Hapeville
georgia

DESIGN REVIEW COMMITTEE

August 16, 2023 6:00 PM

RE: Design Review ~ 3259 Dogwood Drive

CONVO Front Elevation

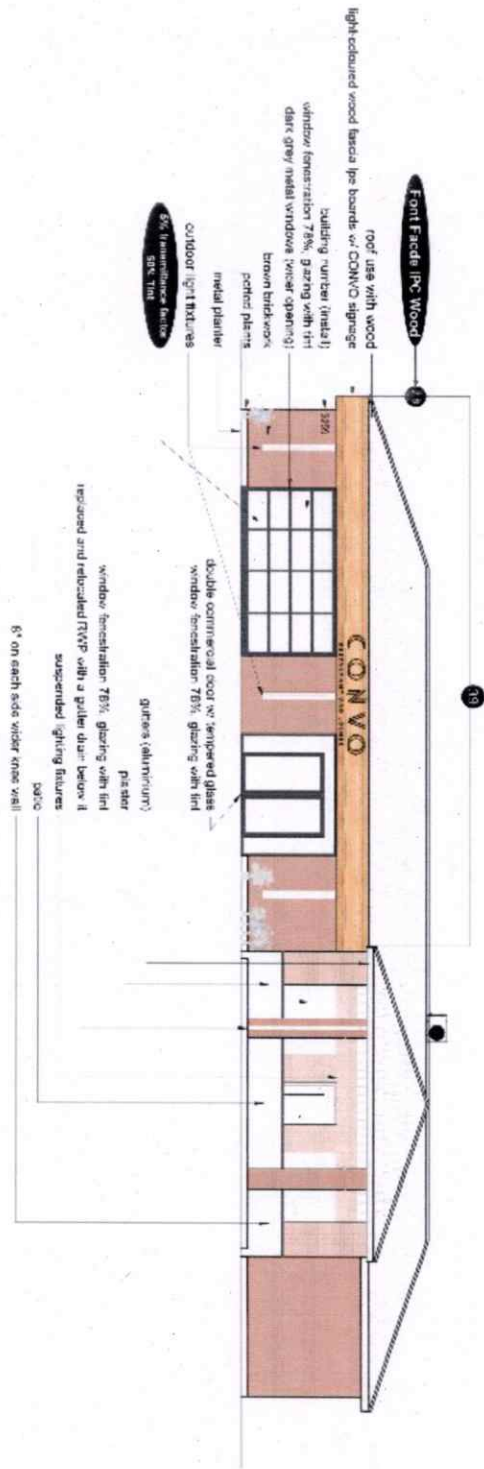
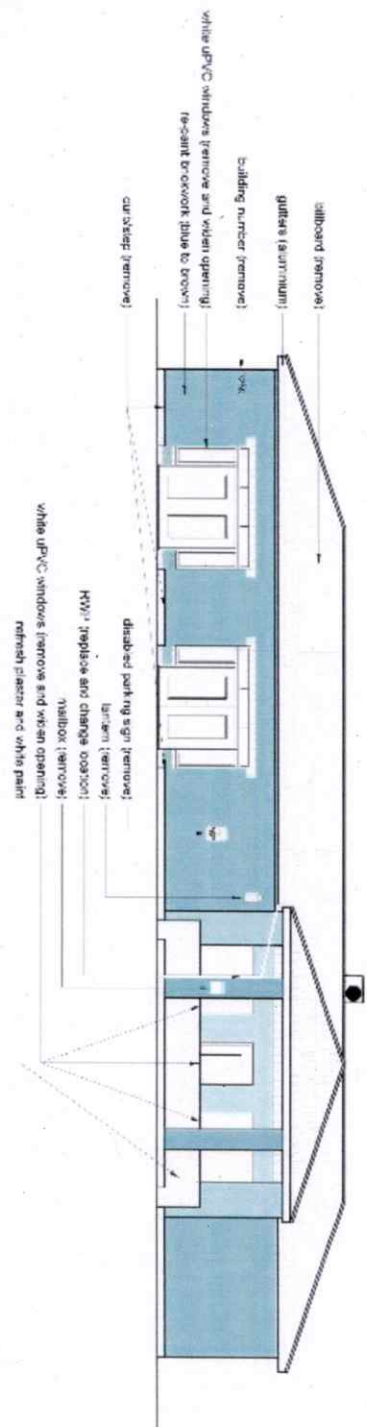
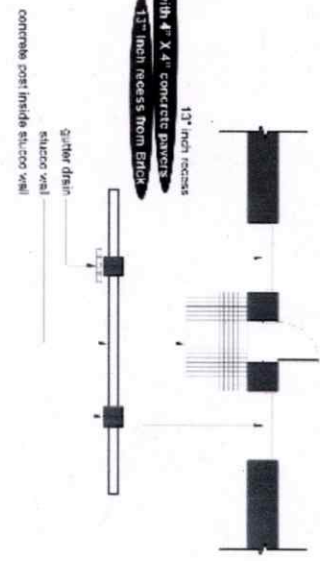
NOTES: *The existing development has parking at the front of the building in the supplemental area. Design Exception required.
The patio walls will be stucco.*

NOTES: *Parking is in the supplemental area and there is no 10' landscape buffer between the parking and the adjacent sidewalk. Design Exception required.
Driveway existing, design exception required.*

The foundation on front is not distinct. Requires design exception.

NOTES: ***Drawings show blank, windowless wall along North Ave. Mural proposed.***

NOTES: *Pavers are shown from door to sidewalk in the drawing.*
Building numbers are shown but not near are not shown adjacent to the front entrance.
No knee wall or transoms in original window design.

Site Plan

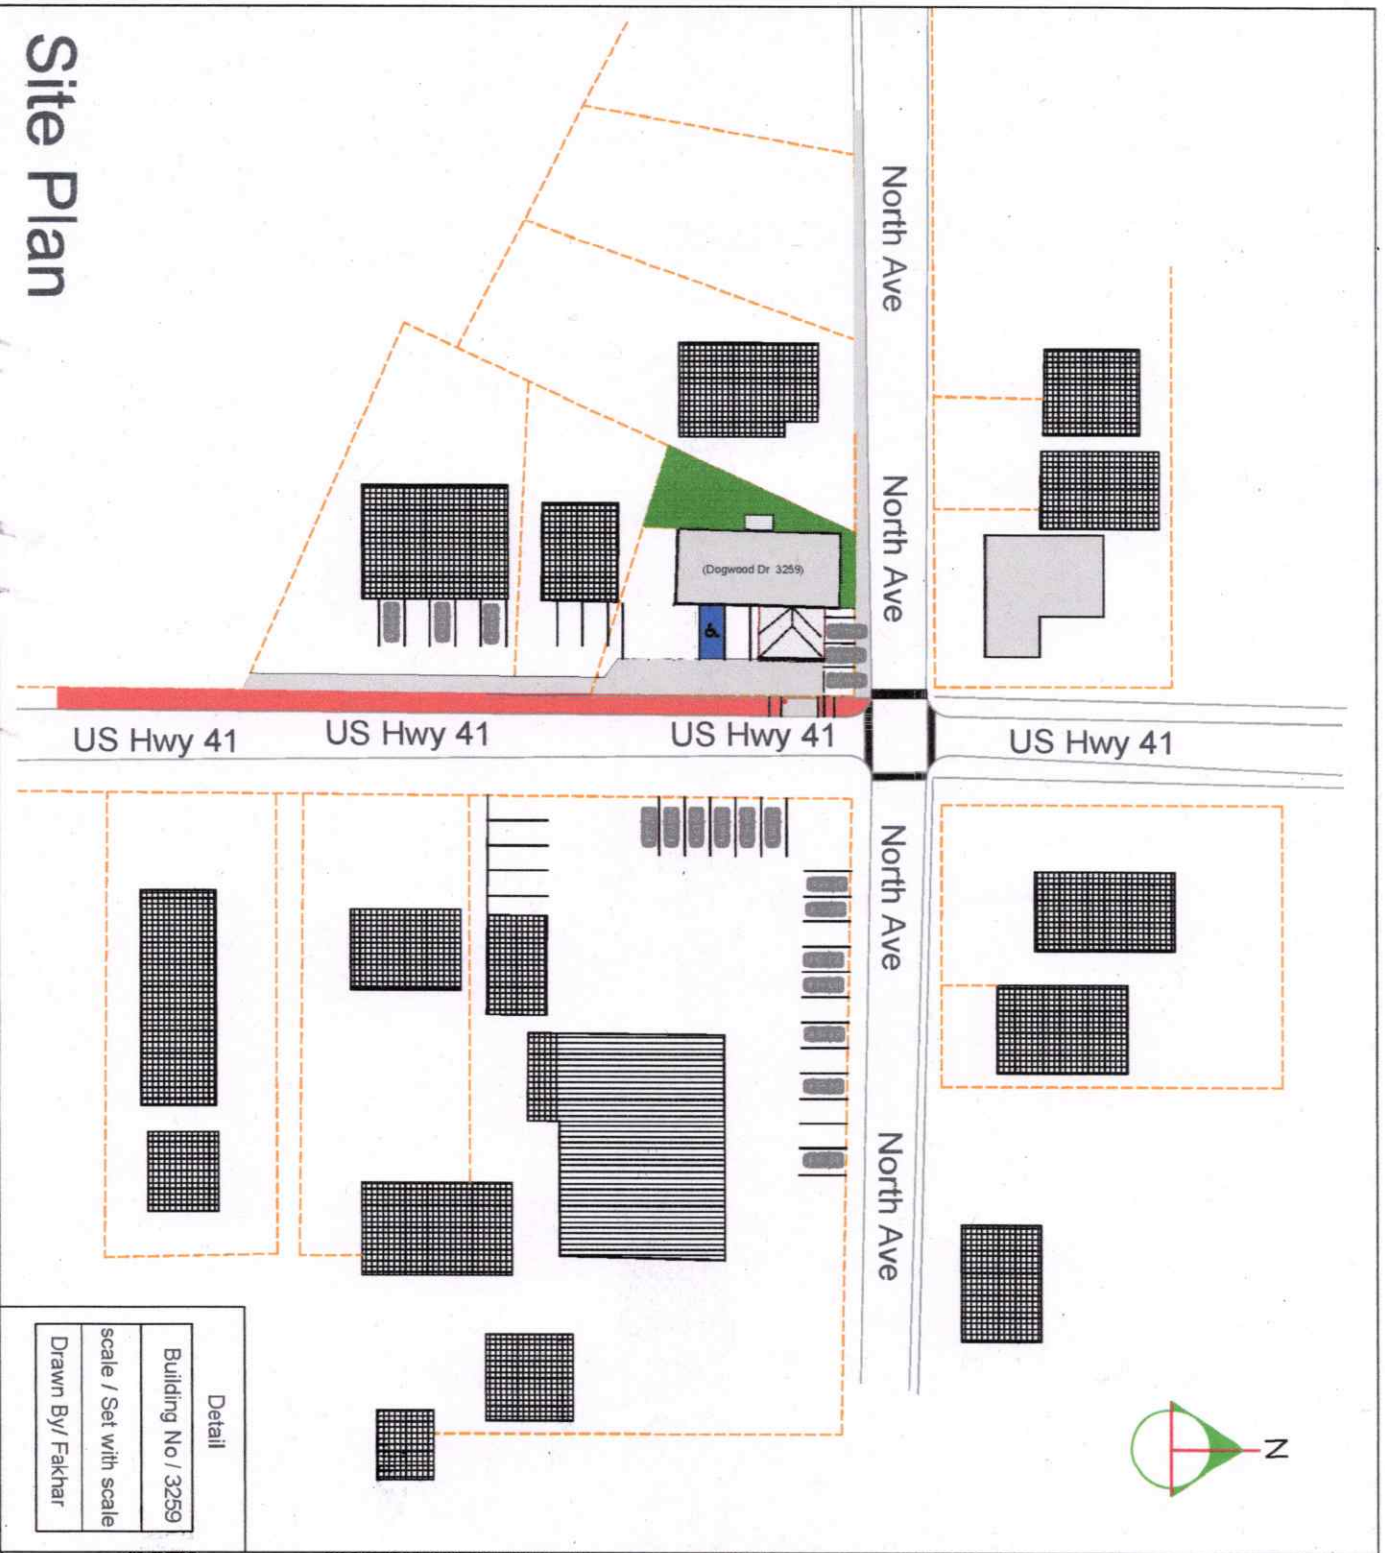
NOTES: *Mechanical is existing on roof. No change proposed.
Dumpster is to the left side and has been shown with screening.*
